SUBSURFACE WASTEWATER DISPOSAL SYSTEM APPLICATION

Street Subdivision Lot #: 825 Eastern Avenue

August 26, 1987
Job No. 87016

Re: Revisions to Required Disposal Bed Bottom/Seasonal Groundwater Separation Distance, Disposal Bed Elevations, and Fill Extension, for Property on Eastern Avenue, Augusta.

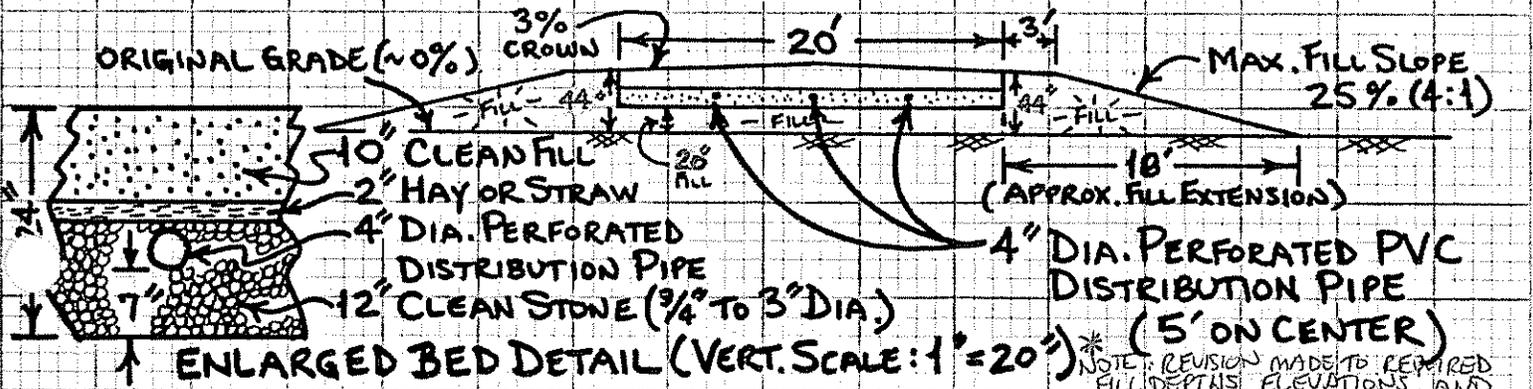
The revisions were necessary to maintain a 2-foot separation distance between the disposal bed bottom and the high seasonal groundwater level. The original copies sent to you incorrectly specified a 1½-foot separation distance, since soil in the "Condition E" category requires the 2-foot disposal bed/groundwater level separation distance.

The plans now call for an overall 44" of fill for the disposal bed, with 20" of fill required from the top of the mineral soil surface to the bottom of the disposal bed. This results in revised elevations of -45.0" to the disposal bed bottom, and -34.0" to the top of the distribution pipes from the elevation reference point. The needed fill extension around the bed is changed to 18 feet.
